HANDBOOK

6170.1

ELECTRONIC EQUIPMENT MODIFICATIONS HANDBOOK - DATA HANDLING EQUIPMENT

DEPARTMENT OF TRANSPORTATION
FEDERAL AVIATION ADMINISTRATION

**M-28-TELETYPEWRITER (6) LEFT
AND FRONT PLATE MODIFICATION
FOR ASR SET MOUNTING.**

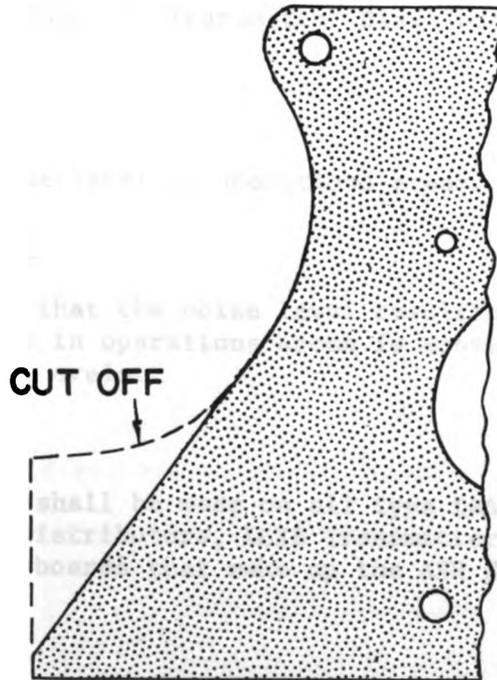
Attachment
Sketch No. SK-A-135-2

FIG. No 1

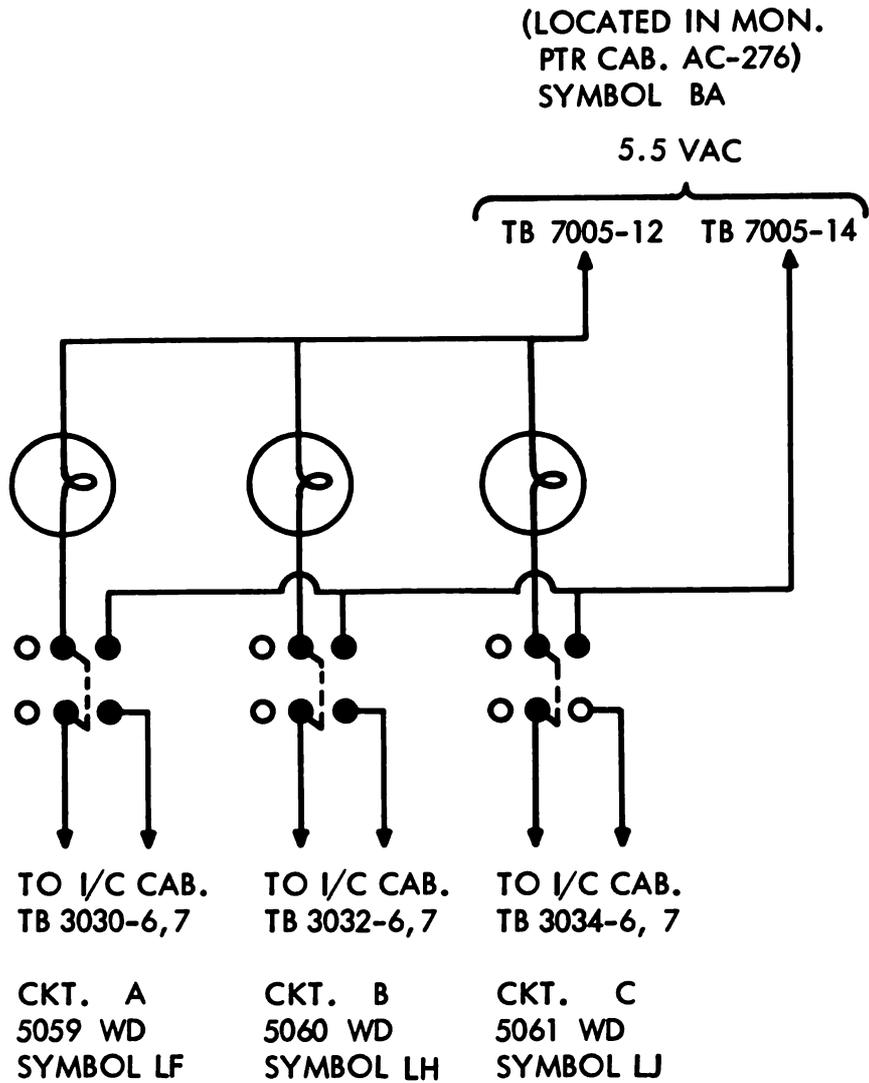
**ADIS - CONTROL OF AREA CIRCUIT
TRANSMISSION**

FIG. 1

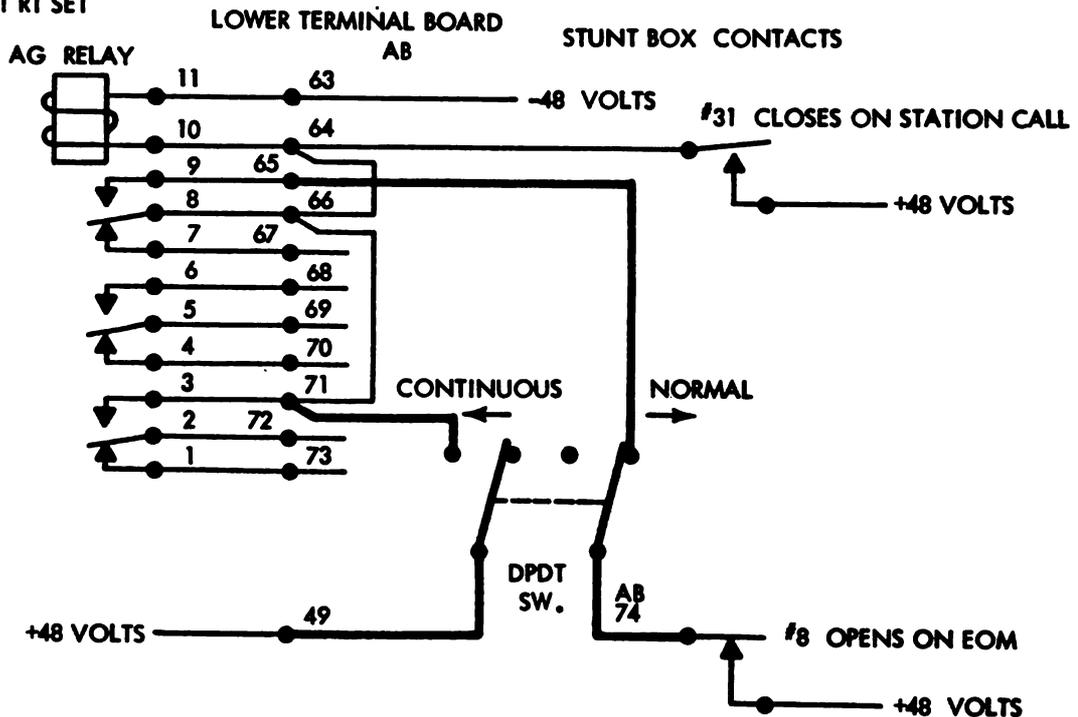
NOTE: HEAVY LINES INDICATE REQUIRED CHANGE

FIGURE 1

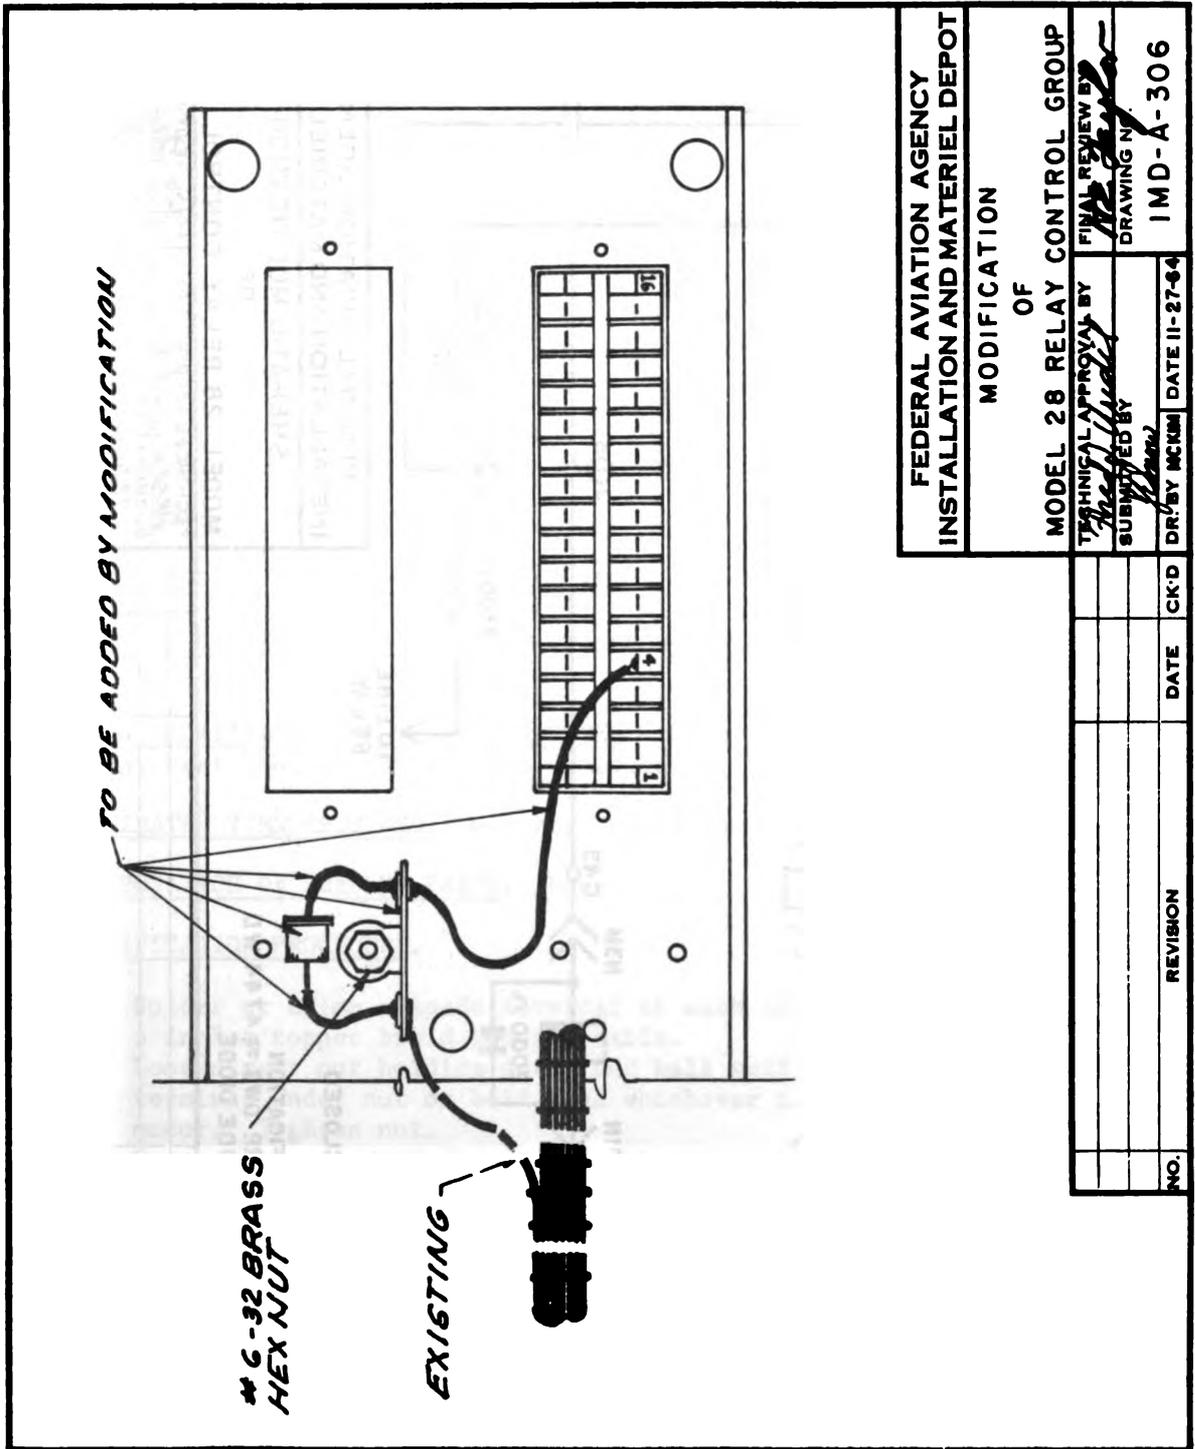
10. ESTIMATED TIME REQUIRED. One man-hour.
11. DISPOSITION OF SURPLUS PARTS. None.
12. MODIFICATION PROCEDURE.
 - a. Remove the relay control group (RCG), Teletype Part No. 179472, from the teletypewriter. Invert the RCG and install the terminal strip (Item 5b) on existing 6032 screw. (See Figure 1) Fasten terminal strip with nut and lockwasher. (Items 5c and 5f)

- b. Mount the semi-conductor diode on the terminal strip with the arrow point toward the 32 point connector. (See Figure 1) Use plastic tubing (Item 5d) to insulate diode leads.

16. CORRECTIONS TO DRAWINGS. Teletype Corporation Drawing 3463WD and 3464WD shall be corrected in red pensil to reflect the addition of the diode.

FIGURE 1
FAA STANDARD STUNT BOX WIRING

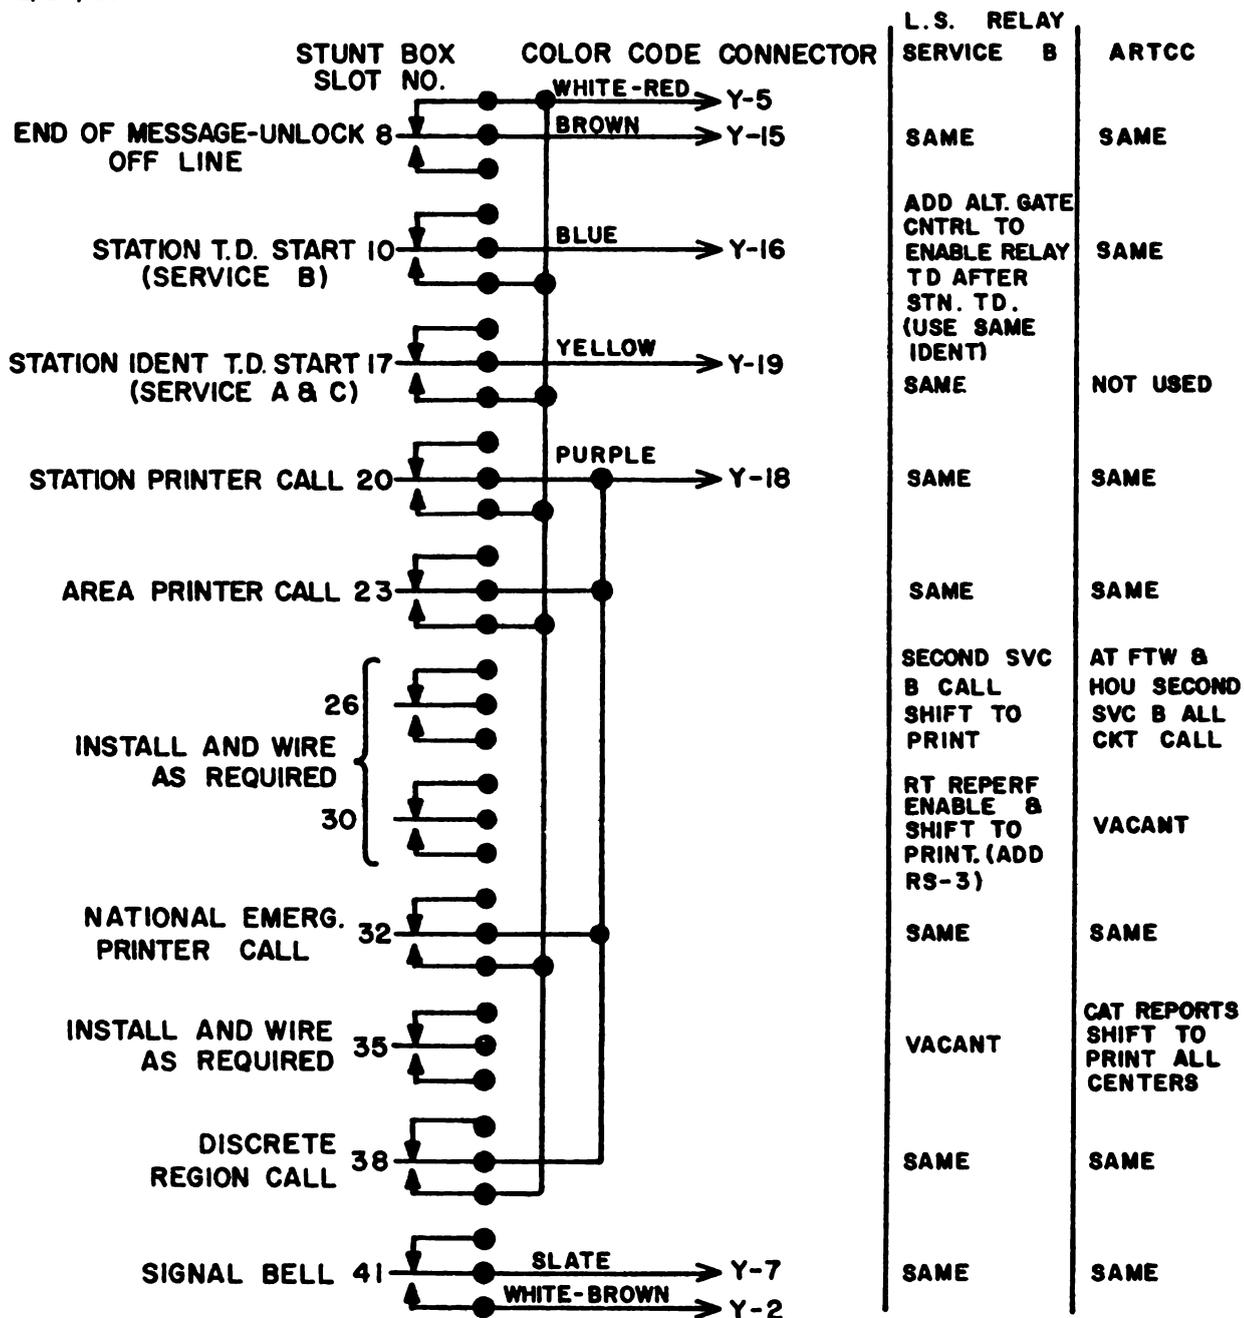
- (8) Connect wires from the stunt box to the #152466 Y cable connector furnished. Wire in accordance with Figures 1 and 2. Do not thread wiring through frame of typing unit.
- (9) Upon completion the #152466 Y cable connector from the stunt box will connect to the inner #152467 Y connector and the cabinet cable connector will connect to the outer R Connector.
- (10) In regions where the VSL series service cable and plug have not been previously installed they should be installed concurrently with this modification. All wiring from the service cable should conform to Figure 4.

FIGURE 3. STRAPPING BETWEEN CONNECTORS ON TYPING UNIT.

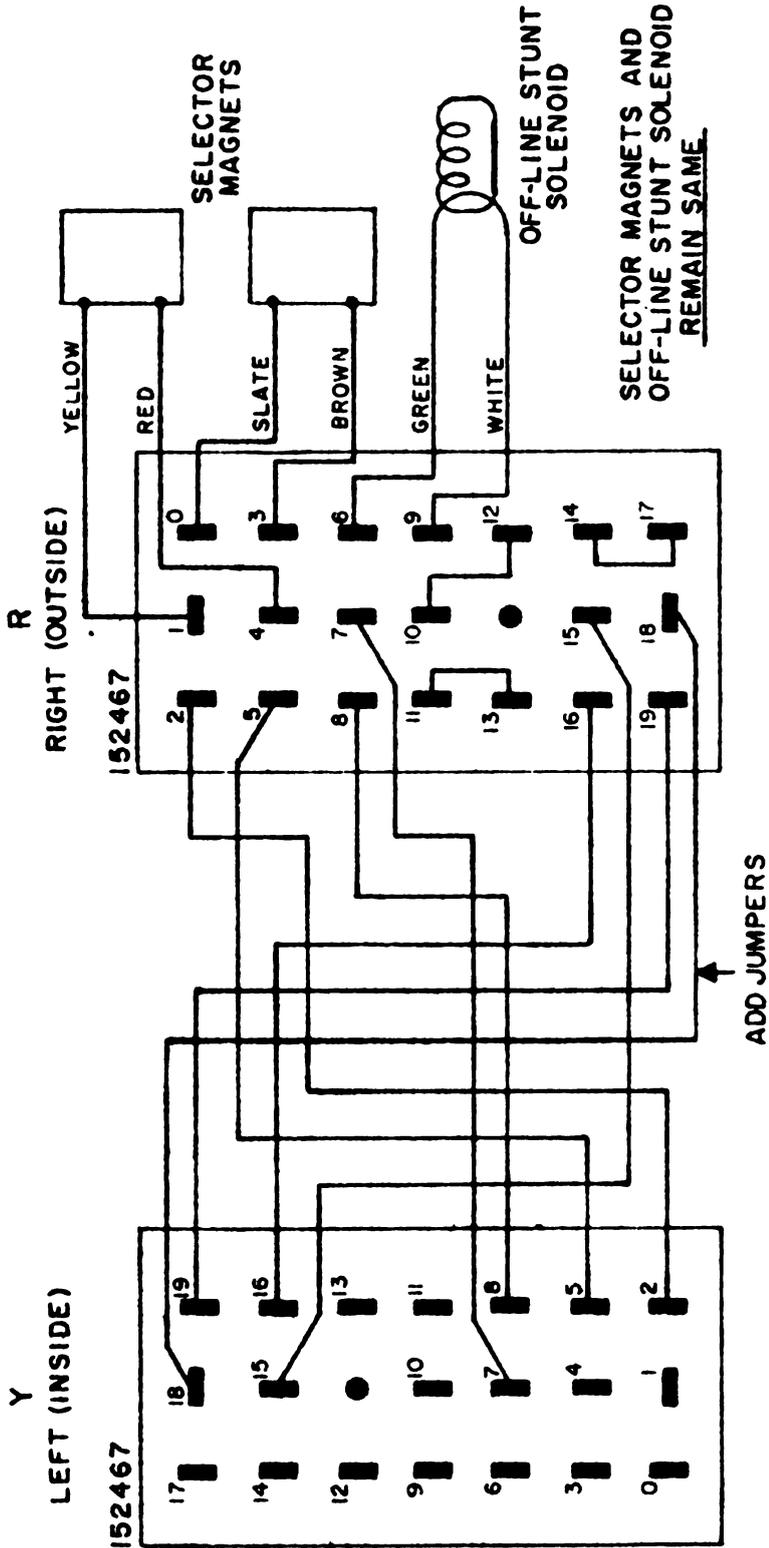
- (7) Refer to Figure 3. Turn typing unit over and jumper the following connections:

1. LEAVE SELECTOR MAGNET AND STUNT SOLENOID AS WIRED
2. STRAP TERMINALS 18 TO 18, 19 TO 19, 16 TO 16, 15 TO 15, 8 TO 8, 7 TO 7, 2 TO 2, 5 TO 5.

FIGURE 1
FAA STANDARD STUNT BOX WIRING

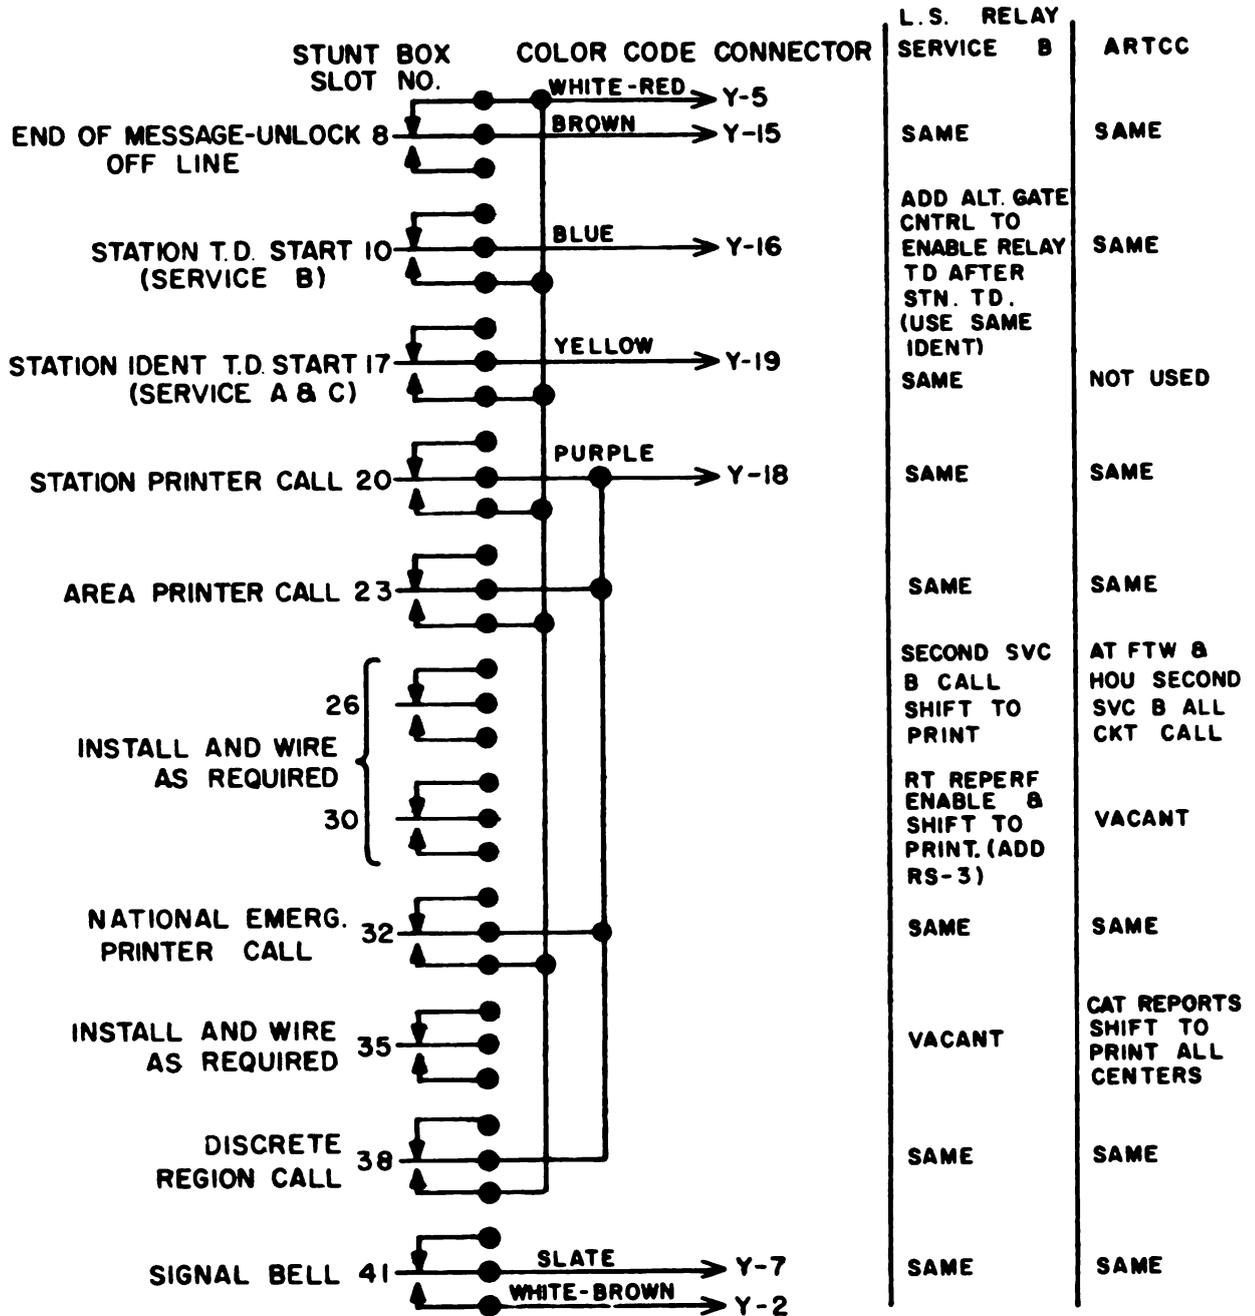
- (7) Refer to Figure 3. Turn typing unit over and jumper the following connections:

FIGURE 3. STRAPPING BETWEEN CONNECTORS ON TYPING UNIT.

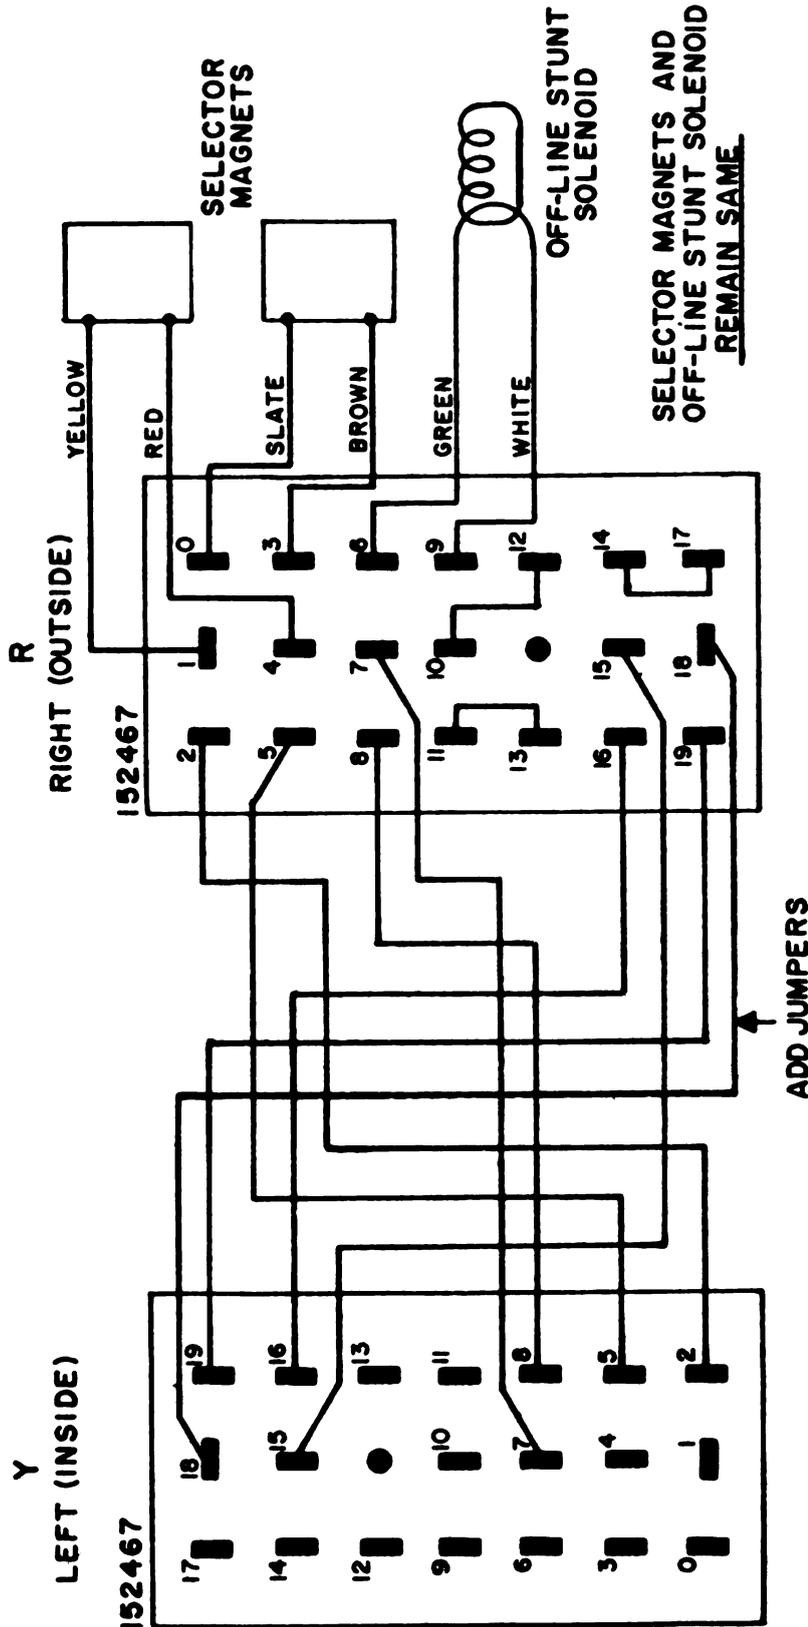
- (7) Refer to Figure 3. Turn typing unit over and jumper the following connections:

1. LEAVE SELECTOR MAGNET AND STUNT SOLENOID AS WIRED
2. STRAP TERMINALS 18 TO 18, 19 TO 19, 16 TO 16, 15 TO 15, 8 TO 8, 7 TO 7, 2 TO 2, 5 TO 5.

FIGURE 2

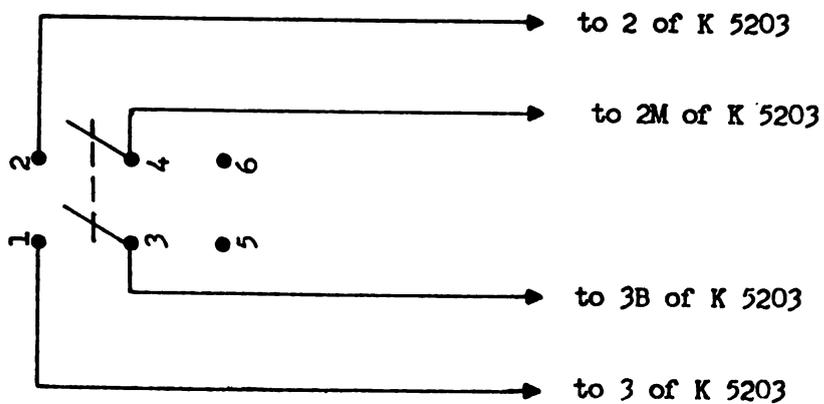
- e. Wiring of the switch. (Reference Figure No. 2)
 - (1) Solder four (4) wires about fifteen (15) inches long to the terminal of the switch as shown in Figure 2.
